# CITY PLAN COMMISSION STAFF REPORT

June 4, 2025

Hickok Homes 39<sup>th</sup> Street

CD-CPC-2025-00055  
*Area Plan Amendment*  
CD-CPC-2025-00054  
*Rezoning*  
CD-CPC-2025-00056  
*Development Plan*

SHEET NAME  
**UTILITY PLAN**

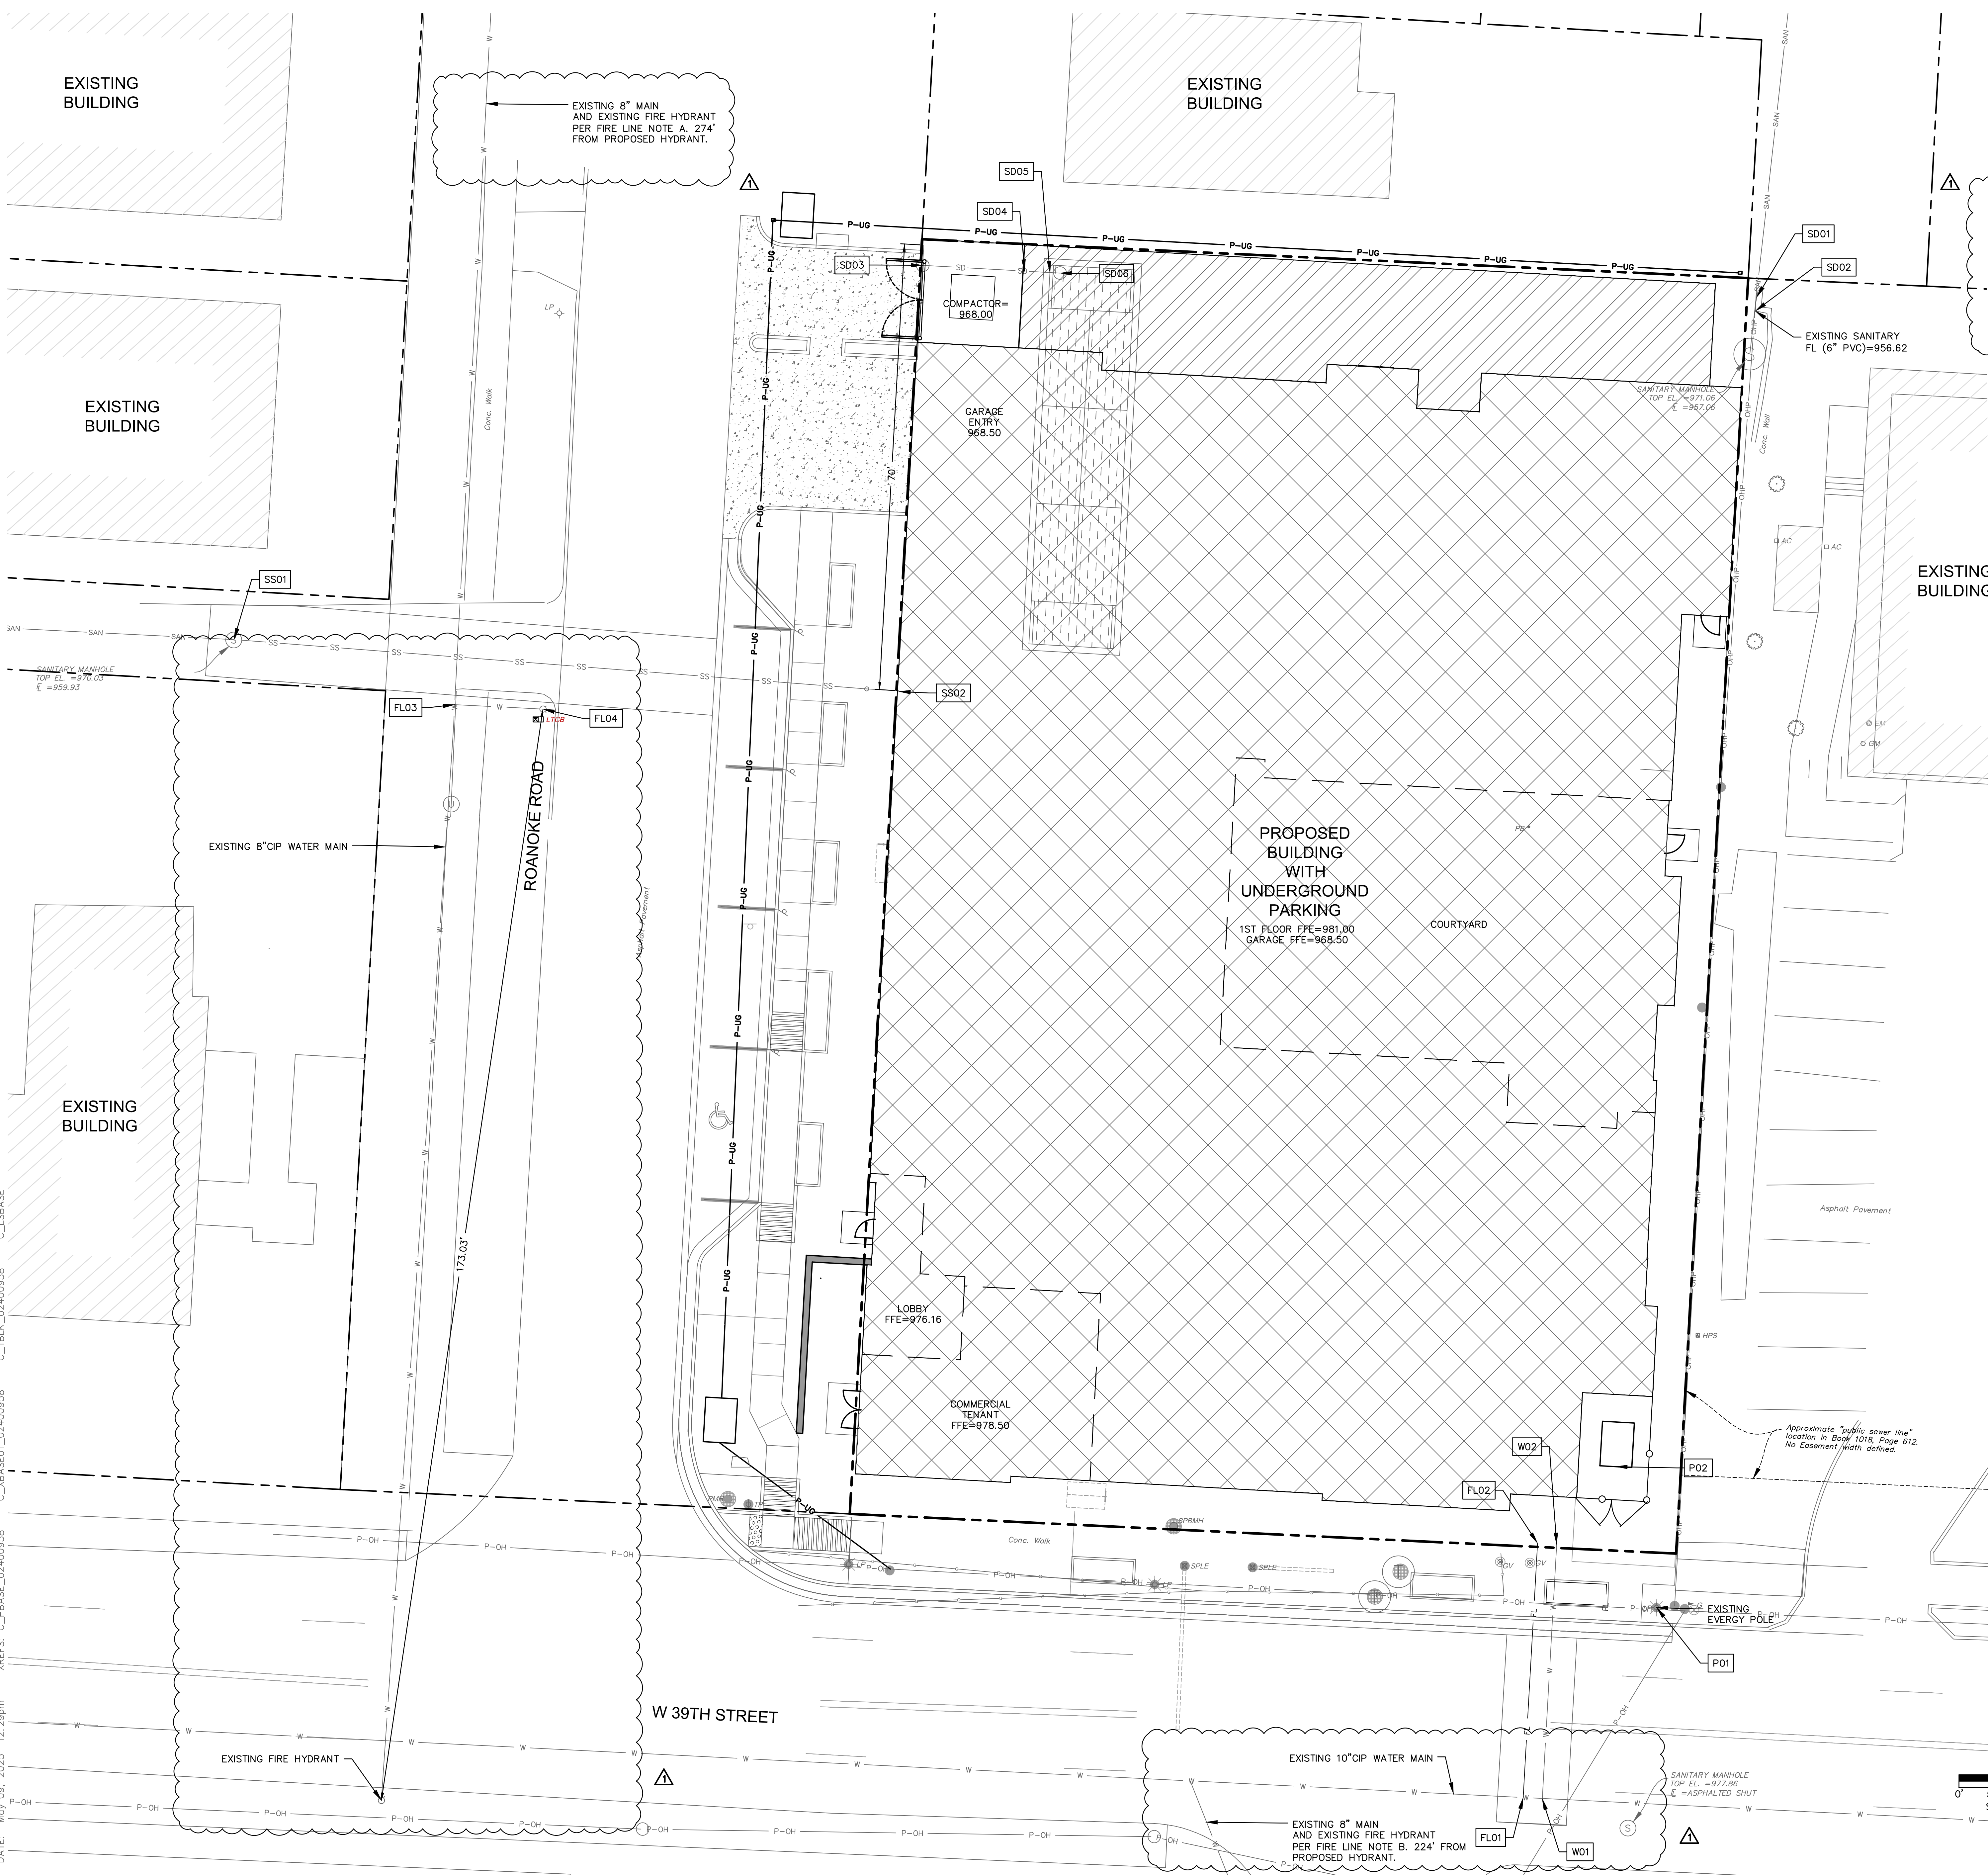
26. The developer provide acceptable easement and secure permits to relocate sanitary sewers out from under proposed buildings and structures, etc. Any existing public lines located under proposed structures must be abandoned in place or removed and easement vacated, or relocated and new easements shall be provided; as required by KC Water prior to issuance of a building permit.

SHEET NAME  
PLANTING PLAN -  
STREETSCAPE  
SHEET NO.

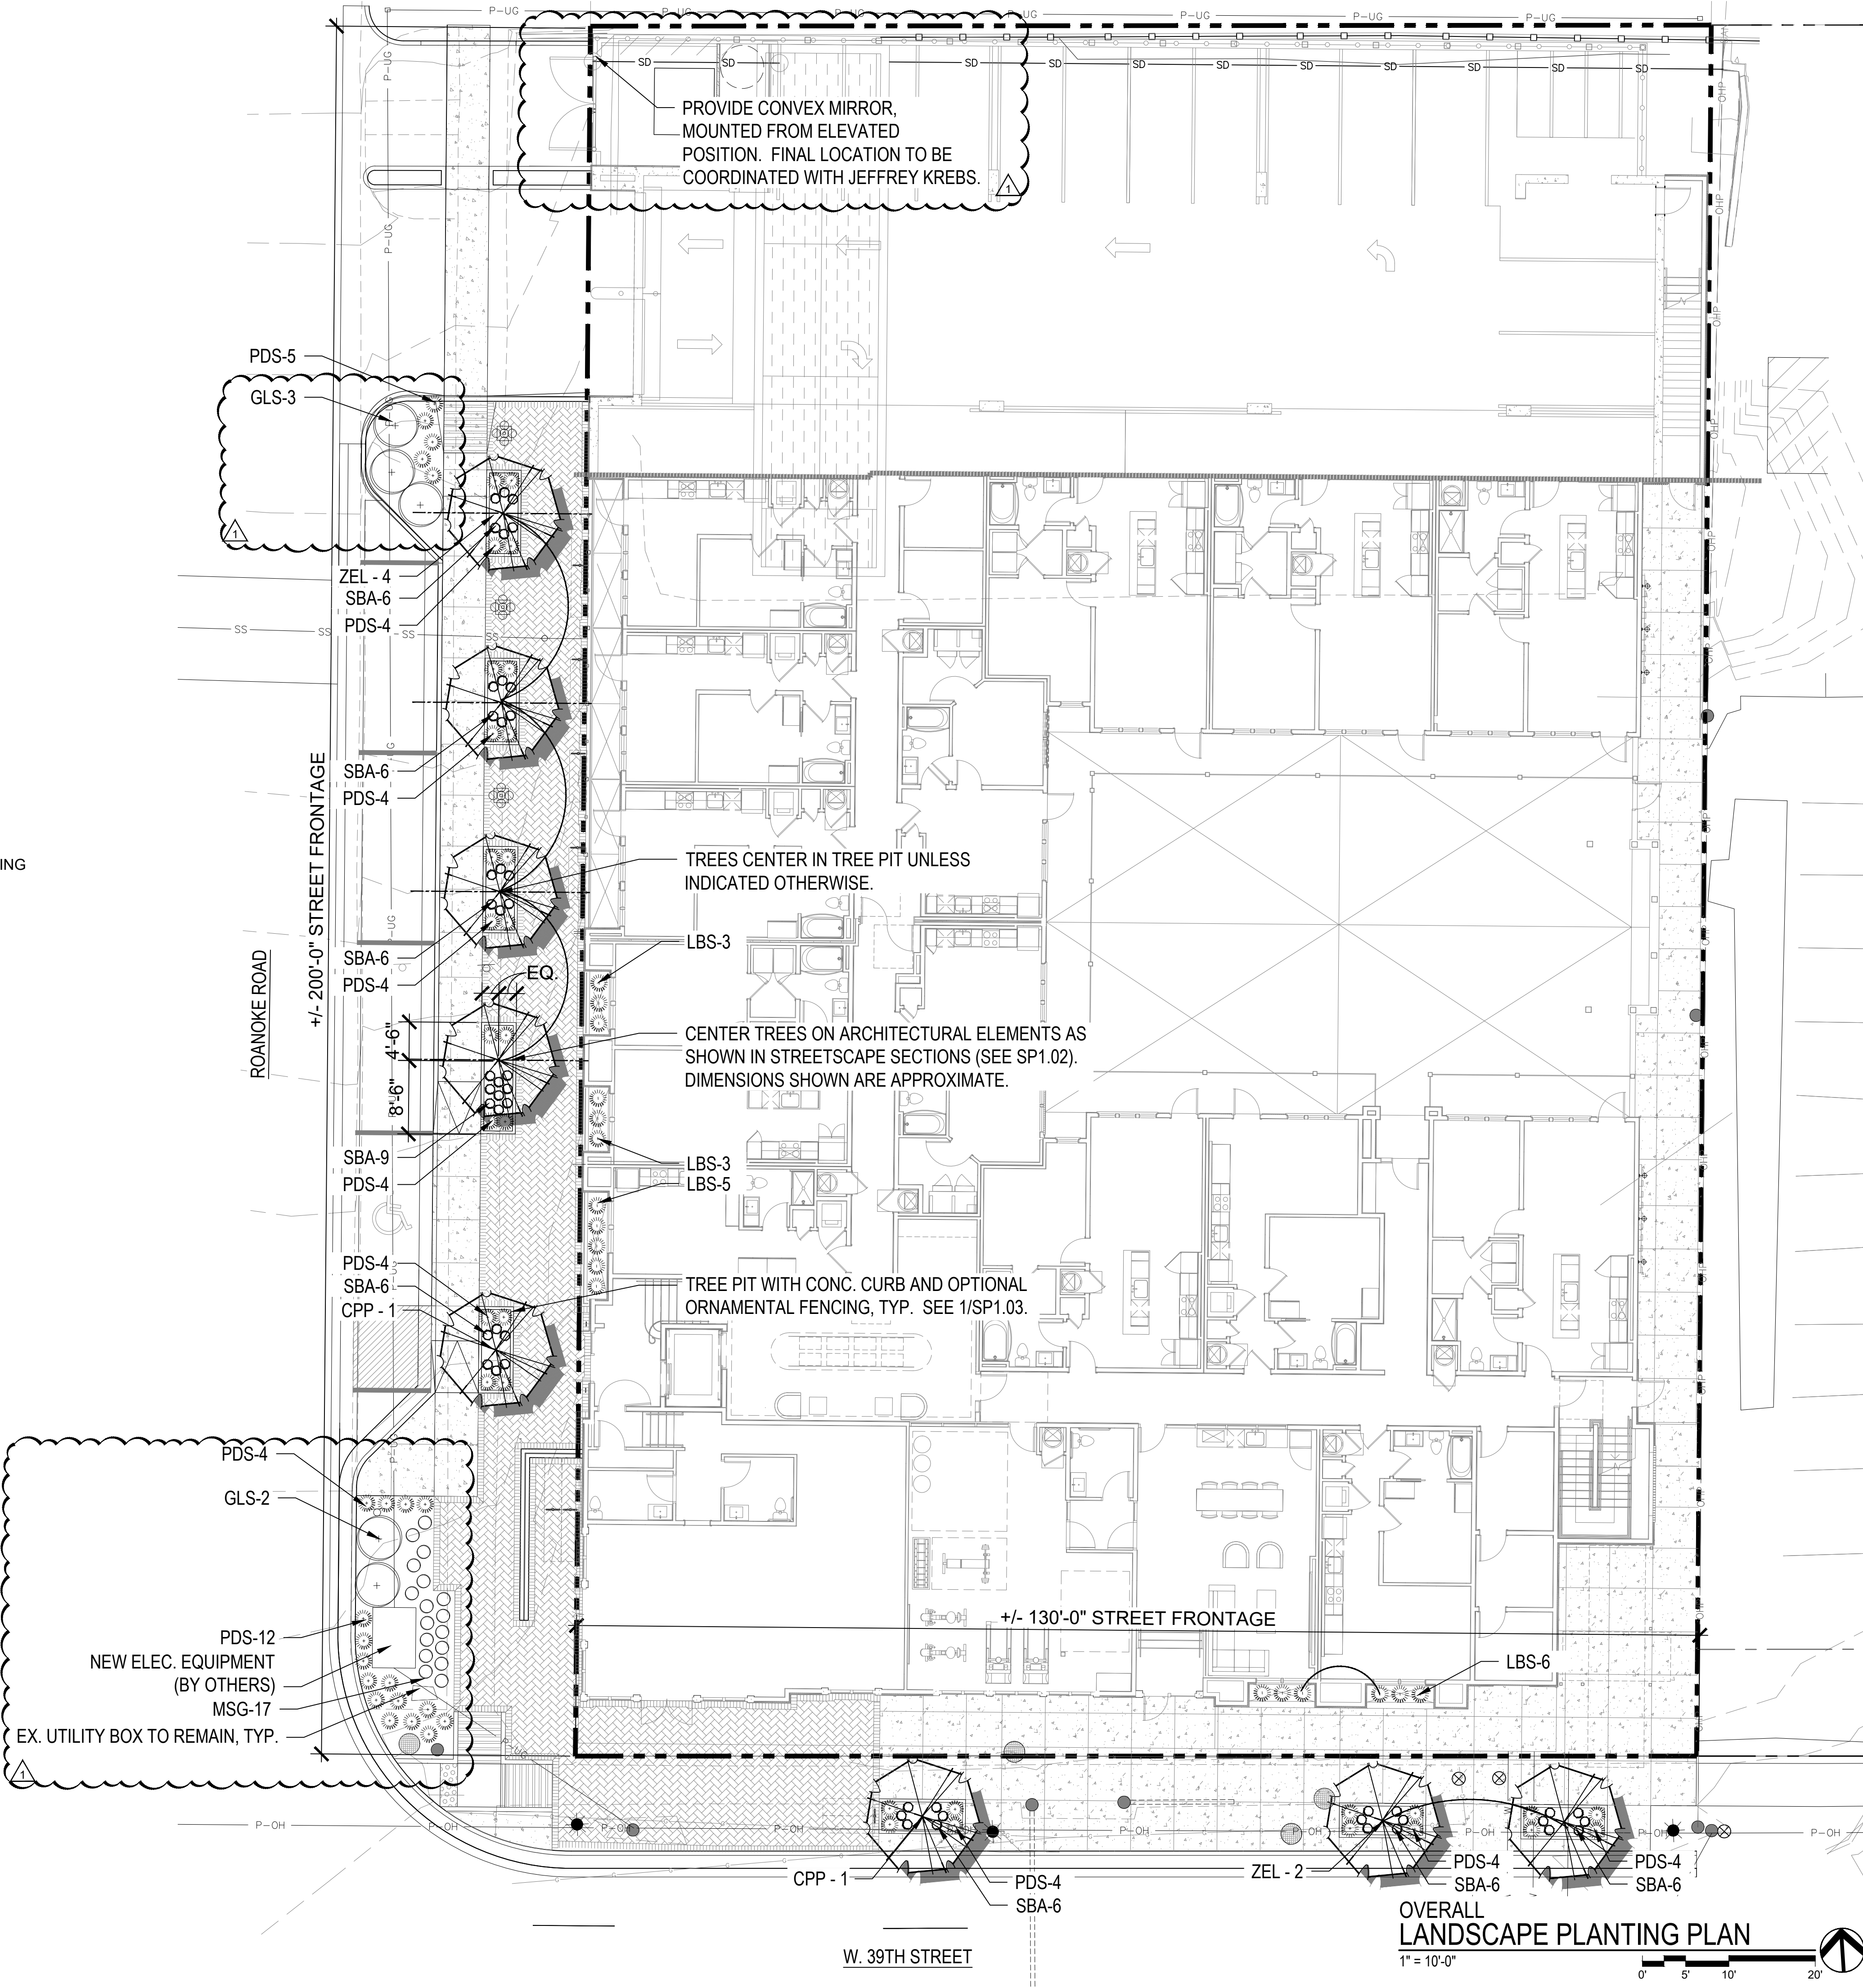
Proposed landscaping considers the site constraints of sidewalk areas available for planting. Due to these constraints, the developer will pay a fee in lieu of the trees they cannot fit onsite. There is a retaining wall that will have updated fencing on the northern property line to screen above-ground parking from adjacent residential properties.
